September 15, 1982

S83-008

The affected model, indicated below, may have three possible defects involving the outer steering arms, the sheet metal plate which positions the lower portion of the main steering shaft, and the forward edge of the track slider frame.

YOU ARE HEREBY NOTIFIED THAT ALL UNITS LISTED BELOW MUST HAVE THE OUTER STEERING ARMS REPLACED ON BOTH SIDES. THE SHEET METAL PLATE WHICH ANCHORS THE LOWER PORTION OF THE MAIN STEERING SHAFT MUST BE RIVETED TO THE BODY AND EXTENSION CAPS MUST BE FITTED TO BOTH LEADING EDGES OF THE TRACK SLIDER FRAME. THESE MODIFICATIONS MUST BE PERFORMED ON ALL MACHINES DELIVERED FROM YAMAHA, WHETHER NOW OWNED BY THE CUSTOMER OR THE DEALER.

#### A EXTENSION CAP INSTALLATION (SUSPENSION RUNNERS)

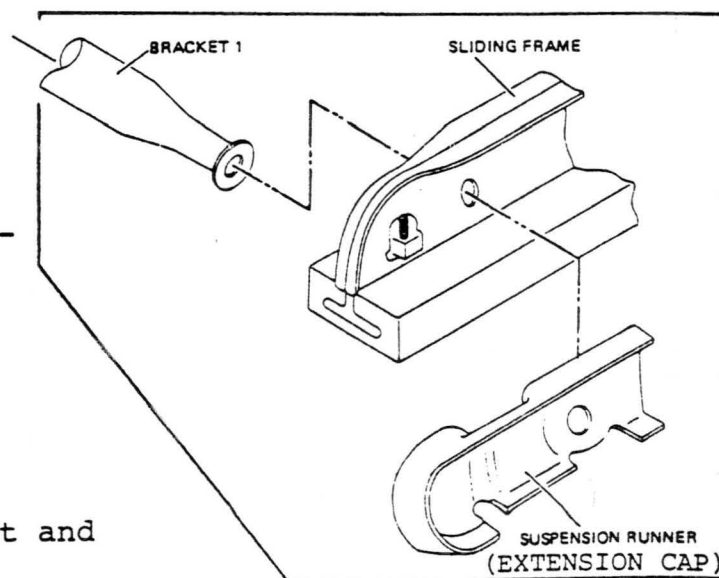
1. Remove the long bolt from bracket 1 located at the leading edge of the track slider frame.
2. Install extension caps to both the right and left leading edges of the track slider frame, as illustrated.

- i) Be sure to position the extension caps properly.
  - ii) Cap 6 (8R4-47321-00) must be fitted to the left-hand side and cap 7 (8R4-47322-00) to the right-hand side.
  - iii) See the instruction sheet contained in the kit.
3. Adjust the track alignment and tension as specified.

Track tension: 25~30 mm (1.0~1.2 in.)/10 kg

B. REPLACEMENT OF OUTER STEERING ARMS AND RIVETING OF STEERING SHAFT BRACKET PLATE.

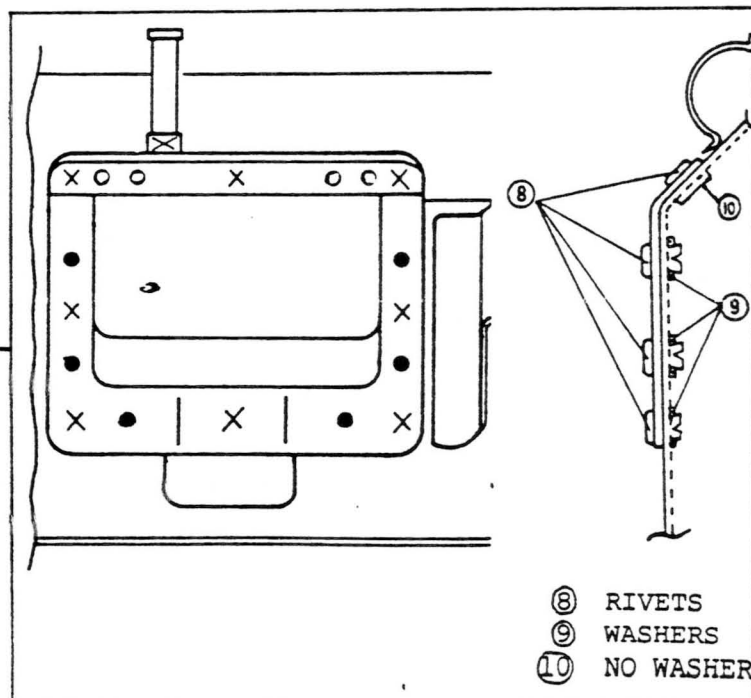
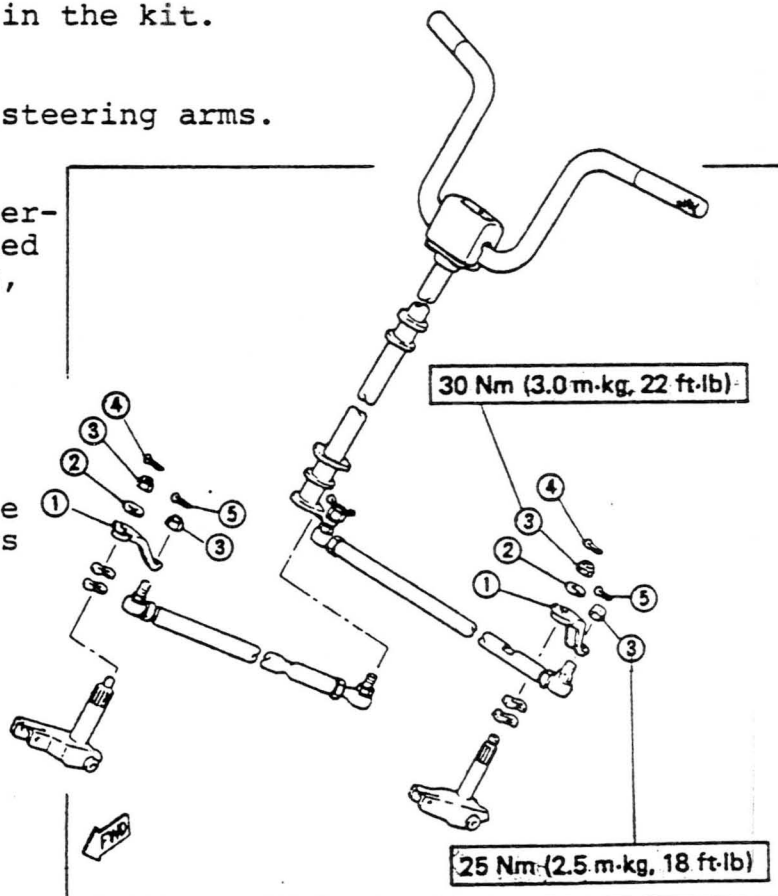
3. Drill ten (10) 4.1 mm holes (#20 drill or 0.16 in.) in the steering bracket plate at the positions indicated by an open circle on the illustration on the next page.

4. Rivet the ten (10) positions illustrated using the washers and rivets contained in the kit.

- i) Use the six (6) washers supplied only at those positions indicated by a solid circle (●) on the back side of the belly pan.
- ii) No washers are to be used at the remaining four (4) positions indicated by an open circle (○).

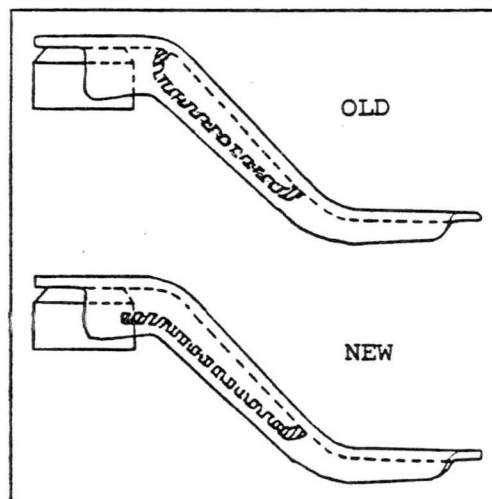
6. Install new outer steering arms as illustrated using the new washers, nuts and cotter pins contained in the kit.

iii) The new and old outer steering arms can be distinguished from one another by comparing them with the illustrations shown opposite.

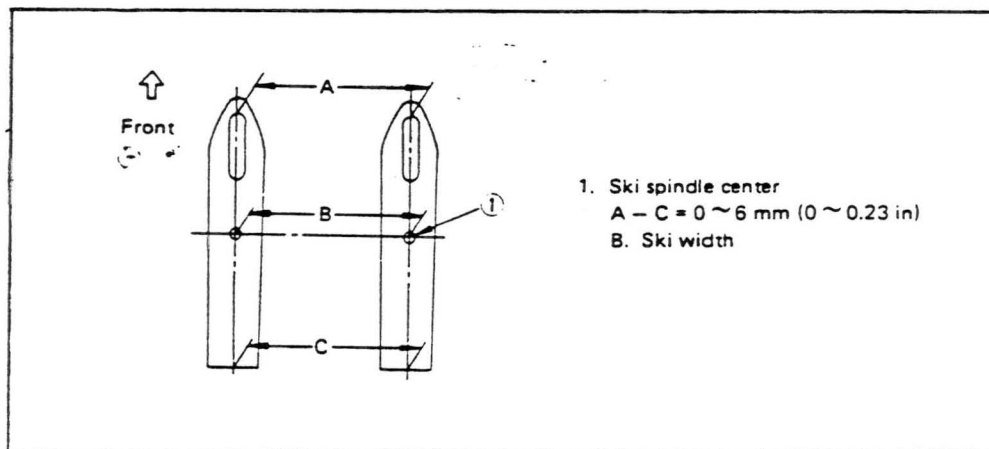
7. Adjust the ski centre-to-centre distance and toe-out:

Centre-to-centre - 750 mm (29.5 in.)

Toe-out - 0 ~ 6 mm (0 ~ 0.23 in.)

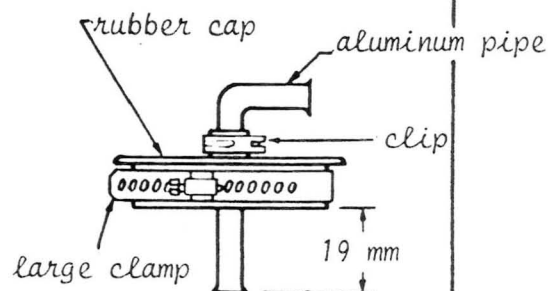
1. Assemble the new suction pipe kit as illustrated.

Slip the large hose clamp over the cap lip, but *do not tighten* the clamp at this point (see step 8).

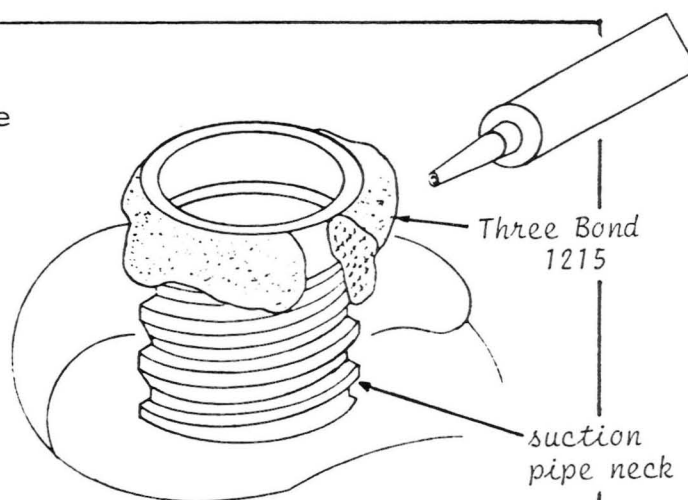
7. Clean the neck (threaded area) of the suction pipe cap and apply Three Bond (#1215) to the threads, as illustrated.

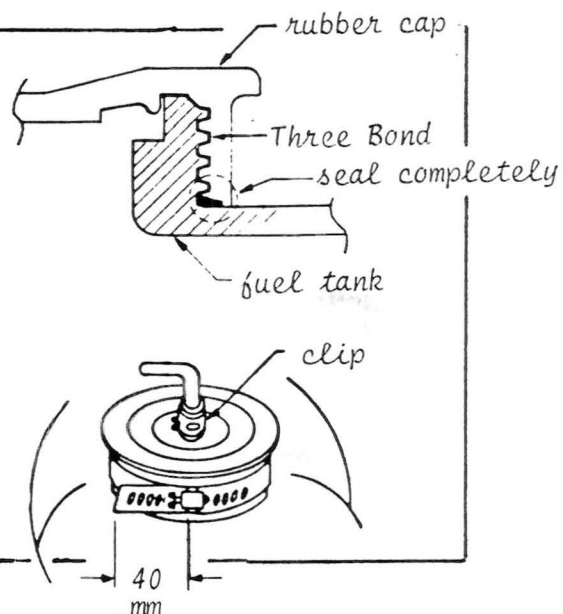
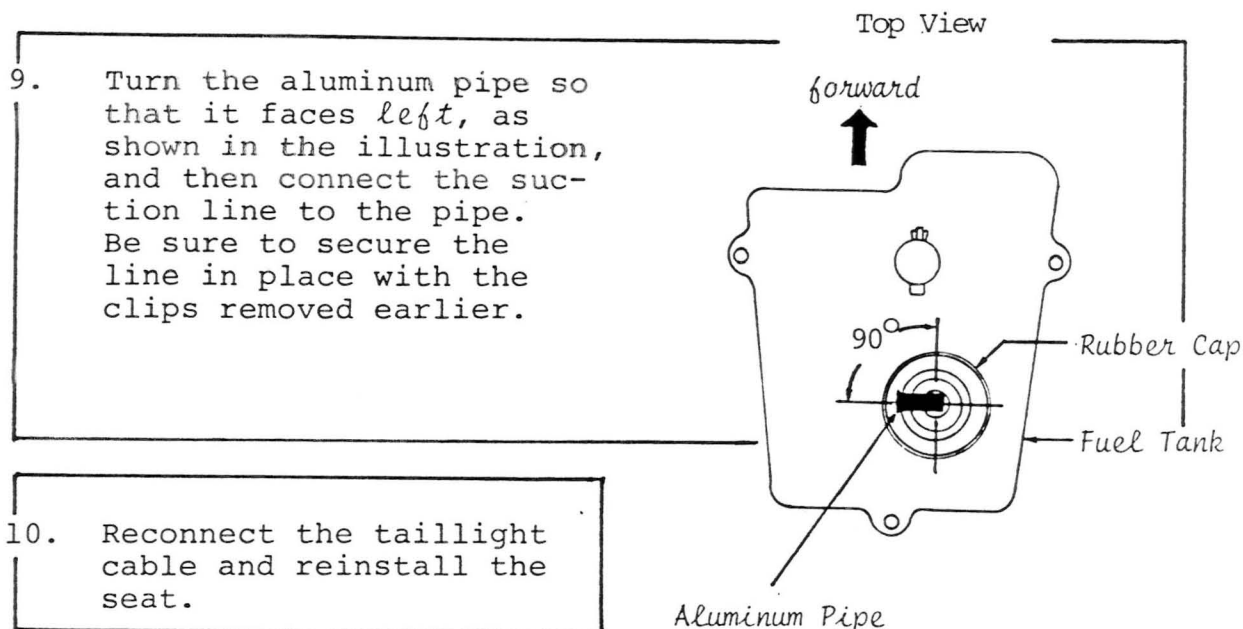
8. Install the suction pipe onto the gas tank and tighten the large hose clamp as illustrated.

Make sure to leave 40 mm (1.57 in.) at the end of the clamp. Do not leave more or less than is specified.

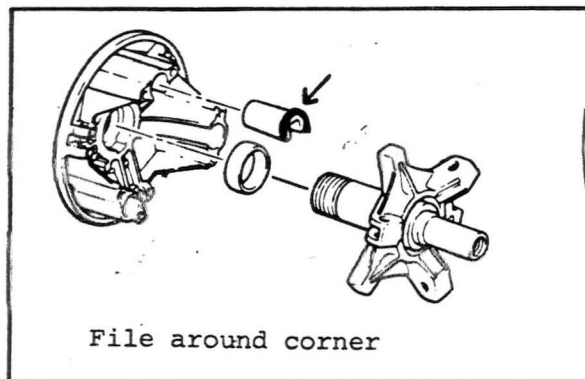
- 4) Using a small half-round file, remove a small amount of material from both corners of each spider finger, as illustrated.

- 6) Spray contact cleaner on both sides of the sliding sheave bushing and its contact area on the post to remove all dirt and grease.
- 7) Again use compressed air to blow the metal filings and dirt out of the clutch.
- 8) Check the plastic sliders for burrs and file until smooth. See illustration below.

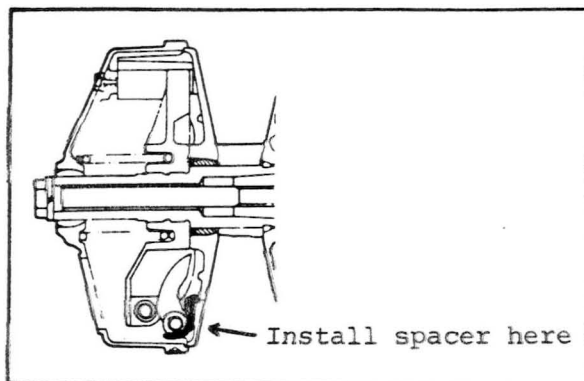
- 1) Install the three spacers contained in the kit between the sliding sheave and each of the clutch weights, as illustrated.

- Note -
- a) After installing the spacers, check the clearance between all weights and rollers by pushing the sliding sheave toward the spider. If there is no clearance, remove the spacers.
  - b) Do not forget to place washers on both sides of the weights.

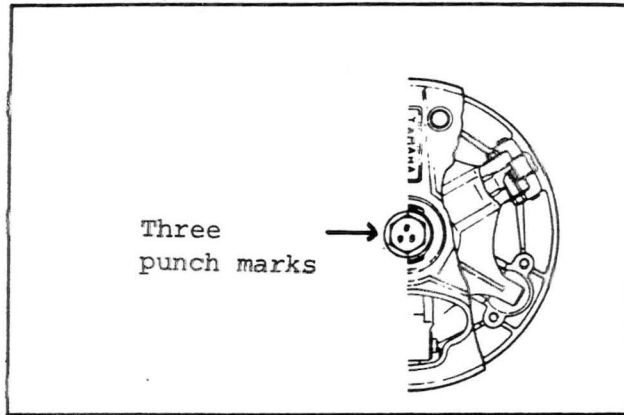
- 1) To indicate that the modification has been done, put three centre punch marks on the primary sheave holding bolt, as illustrated.

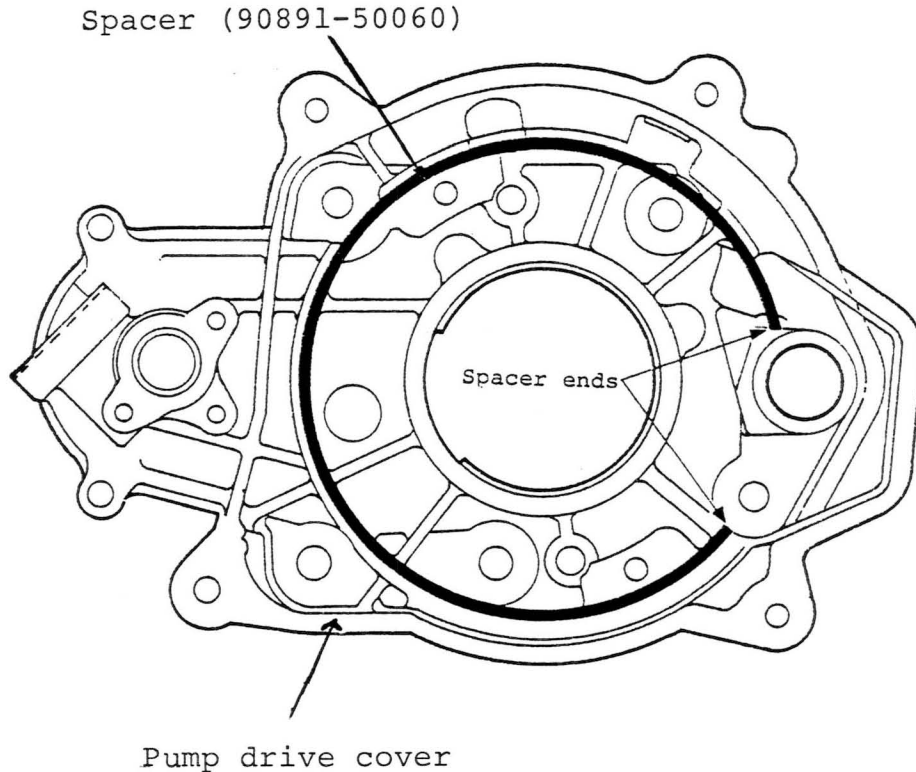
A spacer (90891-50060) which eliminates the uneven seating must be installed on all 1984 VMX540H units whether new or already sold. Please contact owners of delivered units so that this modification may be done.

NOTE: The spacer must be installed with the open ends positioned as shown below.

1985 ET340J; EC340J; PZ480J/EJ;  
XL540J SHAFT-5 REPLACEMENT PROCEDURE

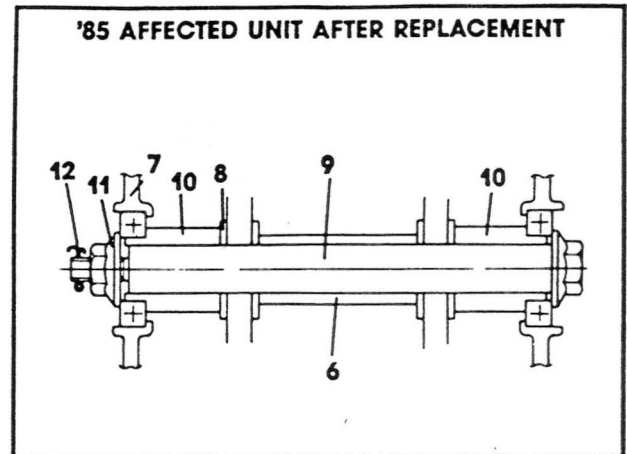
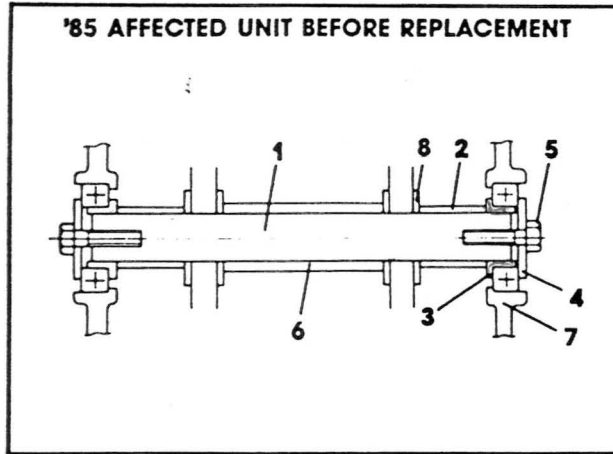
Replace parts #1, #2, #3, #4, and #5 on the affected units with the parts in the replacement kit. Parts #6, #7 and #8 on the affected unit must be reused with the replacement kit.

NOTE: When installing a new Shaft-5 assembly on an '85, use the new shaft to push out the old one. This will eliminate the need to remove the entire suspension assembly.

# 1984 PZ480H SHAFT-5 REPLACEMENT PROCEDURE

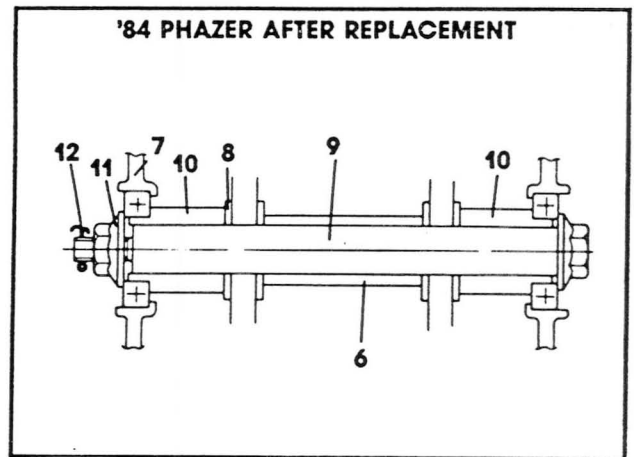
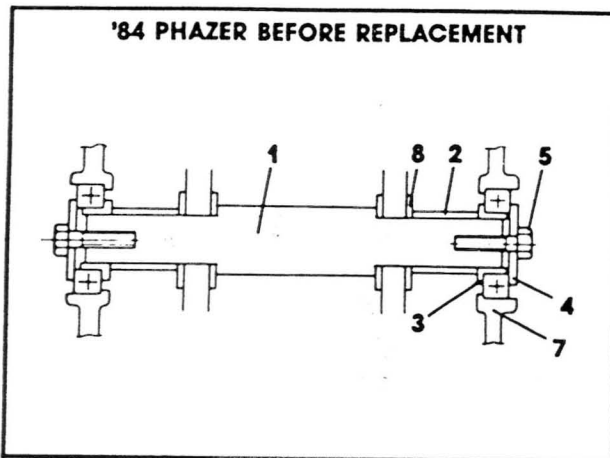
Replace parts #1, #2, #3, #4, and #5 on the affected units with the parts in the replacement kit.

Order part #6. The Shaft-5 assembly design on 1984 Phazers does not include this collar over the centre of the shaft. However, this part is necessary with the new style shaft and must be ordered from your Regional Parts Department in addition to the replacement kit.

Parts #7 and #8 on the affected unit must be reused with the replacement kit.

Illustration 1

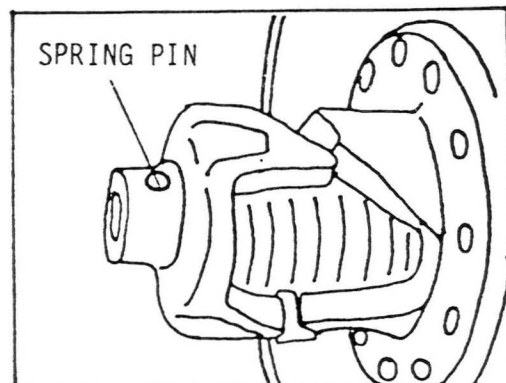
3. Remove the V-belt from the secondary clutch.
4. Remove the spring pin (shown in illustration 1) from the spring seat and secondary shaft using a pin punch.

5. Replace the old spring seat with a new spring seat identified by a blue paint mark.

Illustration 2

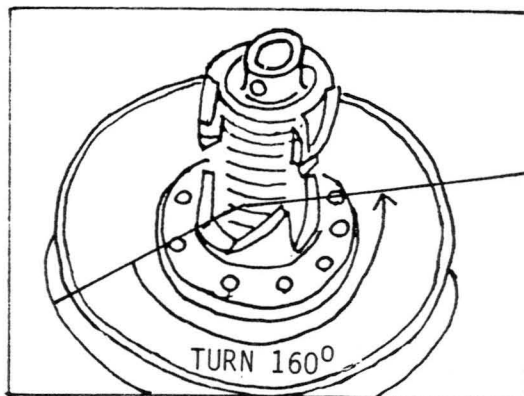
- a) Position the secondary shaft so that the spring pin hole is at the top.
- b) Engage one end of the secondary spring into the sliding sheave and the other into the spring seat.
- c) Install the spring seat half way onto the secondary shaft by applying continuous force.
- d) Insert an appropriate punch into the spring pin hole in the spring seat to prevent the spring seat from moving.
- e) Rotate the sliding sheave 160 degrees (approximately 1/2 turn) counterclockwise, as shown in illustration 2, to set spring preload.

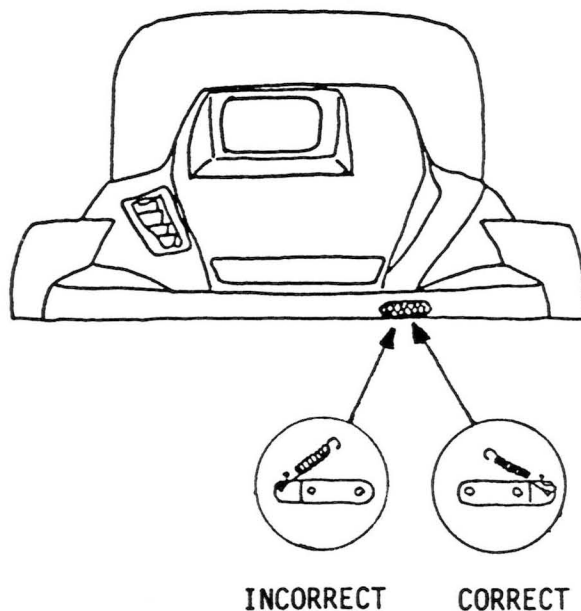
It has been determined that the hood stopper washer has been installed incorrectly on some units. This may cause the washer to catch in the front baffle plate when the hood is opened and closed.

When performing P.D.I. and set-up, be sure to check the position of the hood stopper washer and reposition it as per illustration 1 if incorrectly installed.
